SUBJECT: ISSUANCE OF AMENDMENT FOR THE WASHINGTON PUBLIC POWER SUPPLY SYSTEM
NUCLEAR PROJECT NO. 2 (TAC NOS. M87076 AND M88625)

The Commission has issued the enclosed Amendment No. 137 to Facility Operating License No. NPF-21 for WPPSS Nuclear Project No. 2. The amendment consists of changes to the Facility Operating License and Technical Specifications (TSs) in response to your application dated July 9, 1993, as supplemented by letters of October 8 and October 25, 1993, January 6, January 6, February 2, May 3, May 13, September 26, and October 12, 1994.

The amendment increases the authorized maximum power level of the reactor from the current limit of 3323 megawatts thermal (Mwt) to 3486 Mwt. The amendment also modifies TSs to incorporate the increased power limit in the plant operating limits. This request is in accordance with the generic power uprate program for boiling-water reactors (BWRs) established by the General Electric Company and approved by the NRC staff in a letter dated September 30, 1991.

CORE FLOW (% RATED)
 Operating Region Limits of Specification 3.2.6
 Figure 3.2.6-1

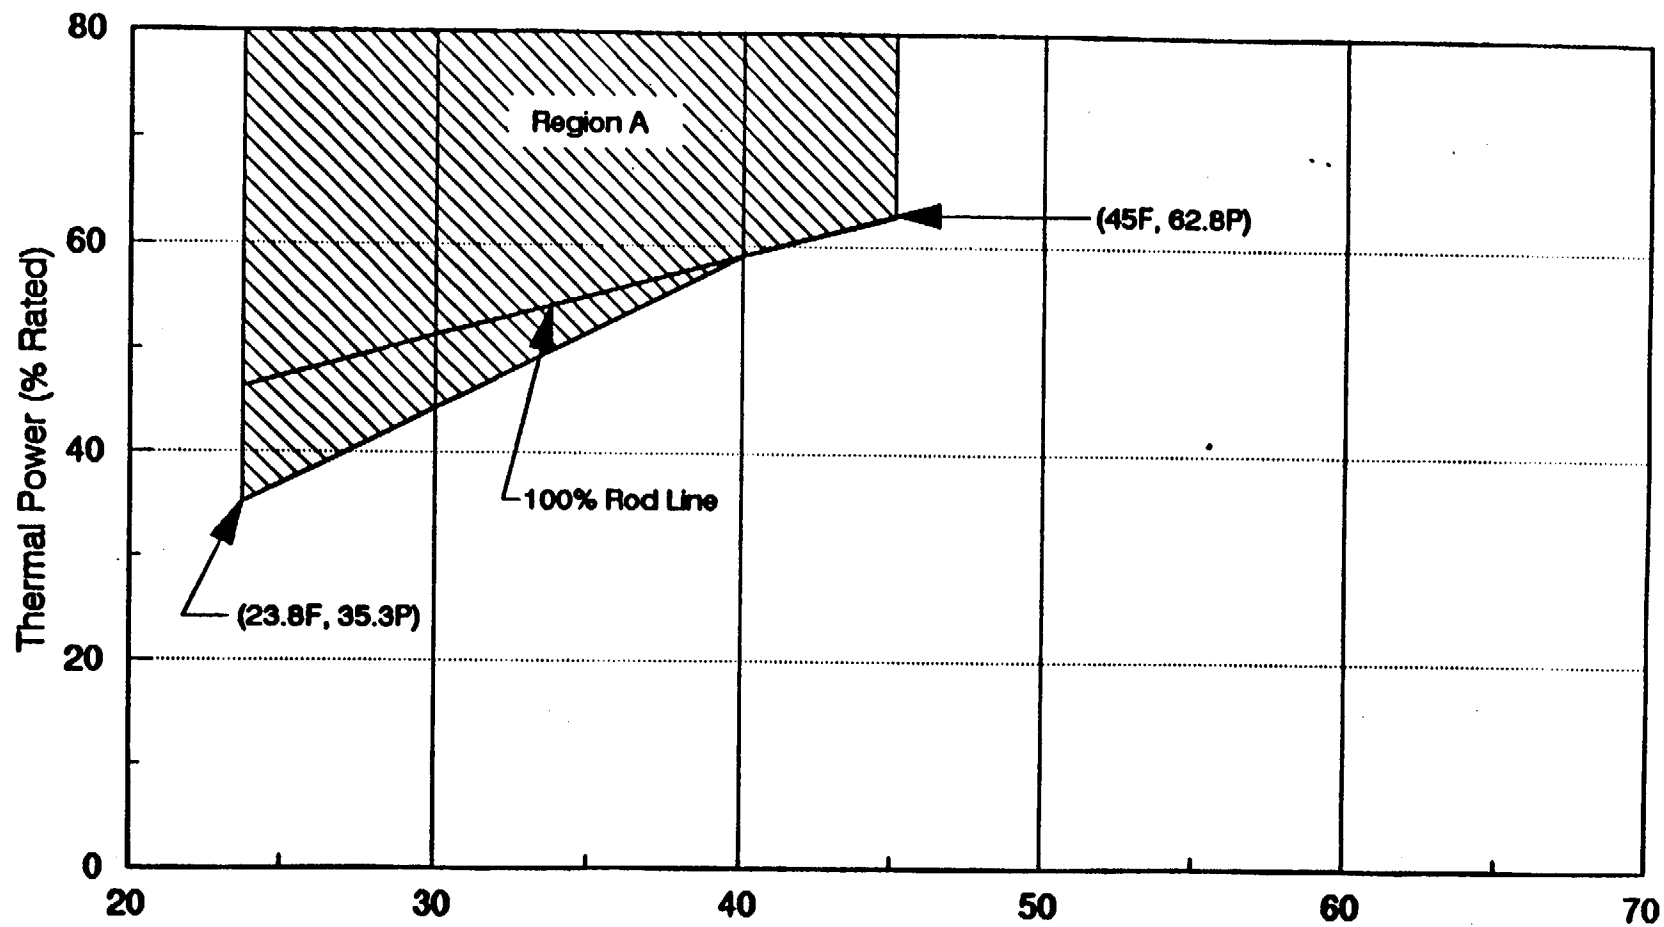
3.2.6 Operation with THERMAL POWER/core flow conditions which lay in Region A of Figure 3.2.6-1 is prohibited.

With THERMAL POWER/core flow conditions which lay in Region A of Figure 3.2.6-1, then as soon as practical, but in all cases within 15 minutes, initiate a MANUAL SCRAM.

4.2.6 The THERMAL POWER/core flow conditions shall be verified to lay outside Region A of Figure 3.2.6-1 once per 24 hours when operating in the region of APPLICABILITY.

Core Flow (% RATED)
Operating Region Limits of Specification 3.2.8
Figure 3.2.8-1

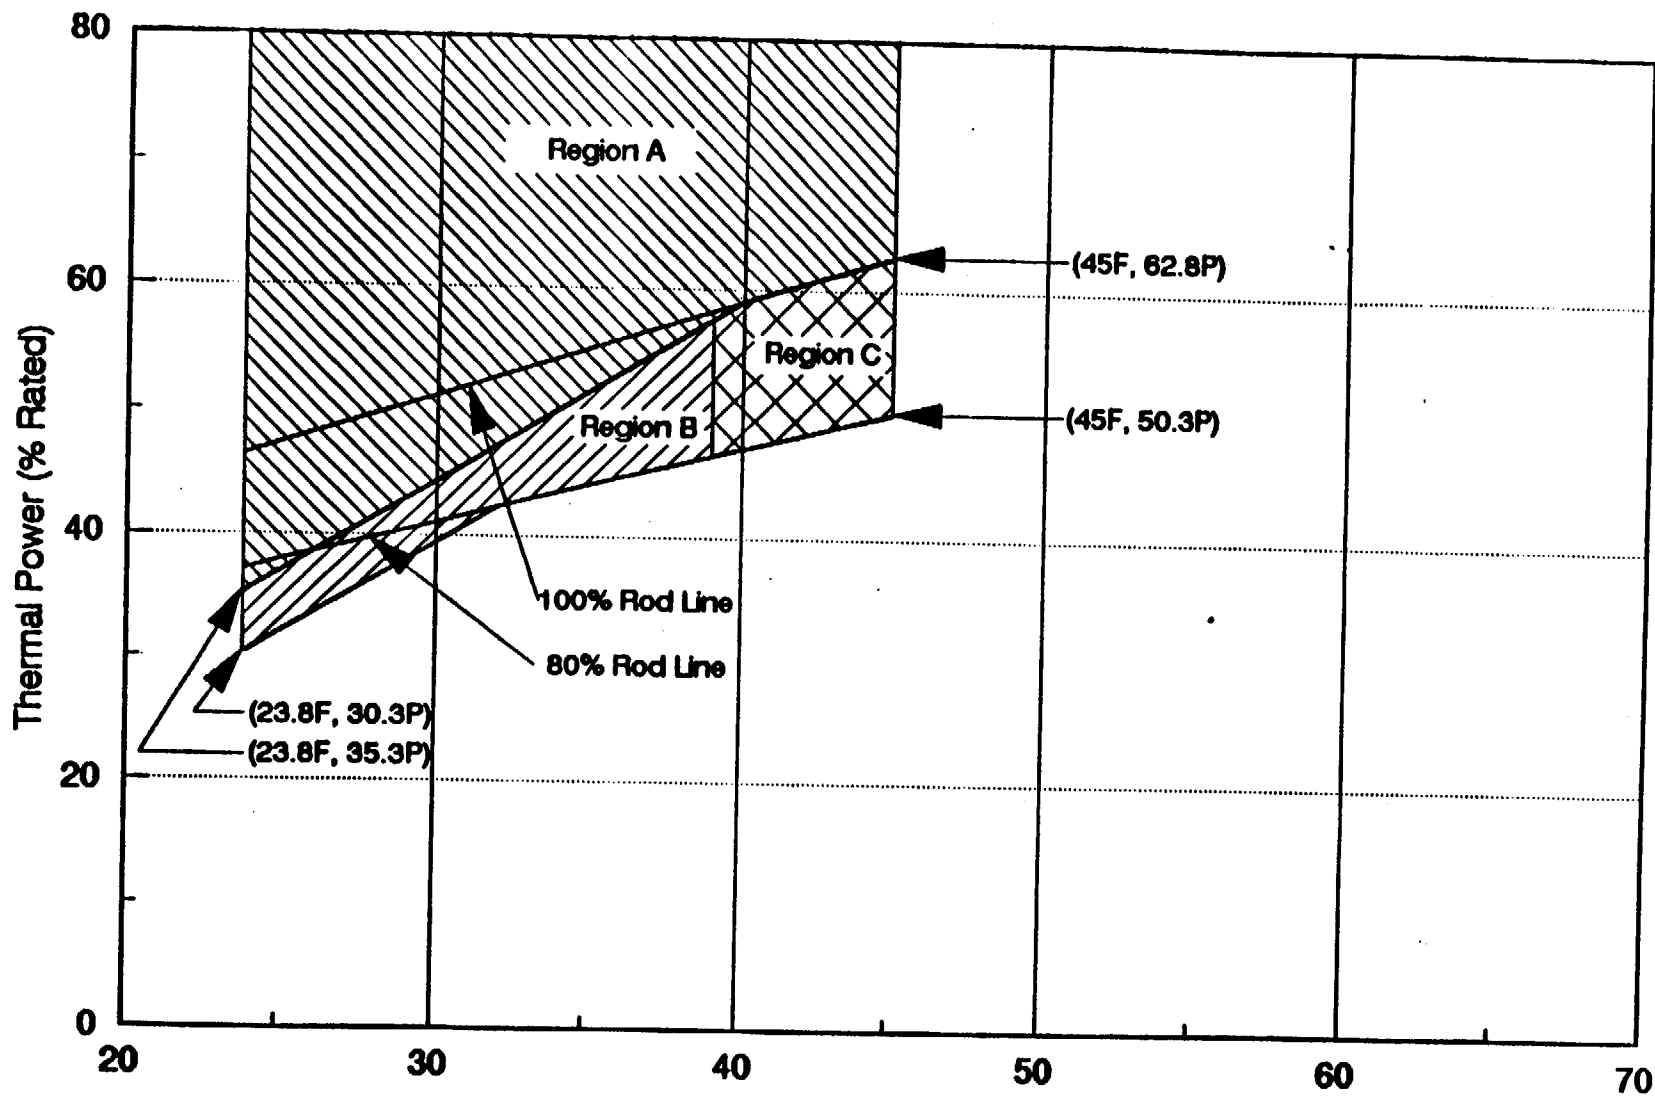
APPLICABILITY: OPERATIONAL CONDITION 1, with one recirculation loop in operation and THERMAL POWER/core flow conditions which lay in Region C of Figure 3.2.8-1.

Core Flow (%Rated)
OPERATING REGION LIMITS OF SPECIFICATION 3.4.1.1
FIGURE 3.4.1.1-1

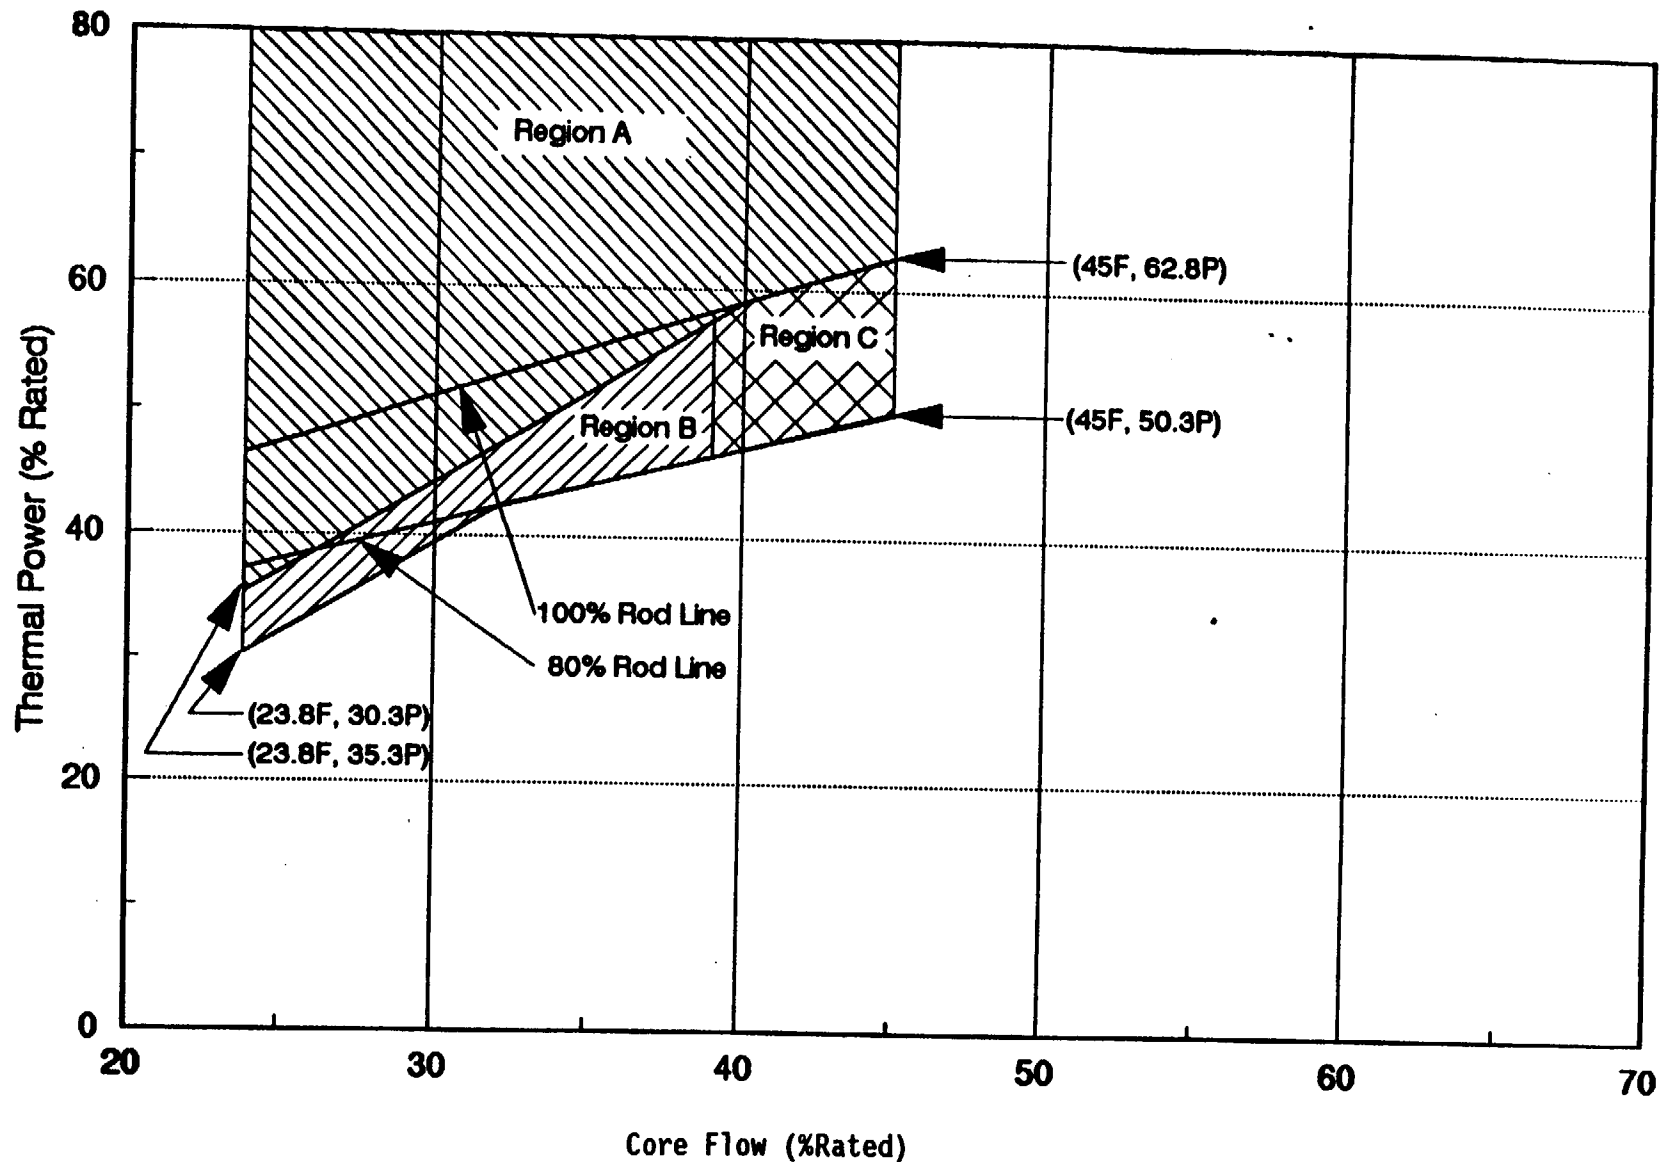
- c. Core flow is greater than or equal to 39% of rated core flow when core THERMAL POWER is greater than the limit specified in Figure 3.4.1.1-1.
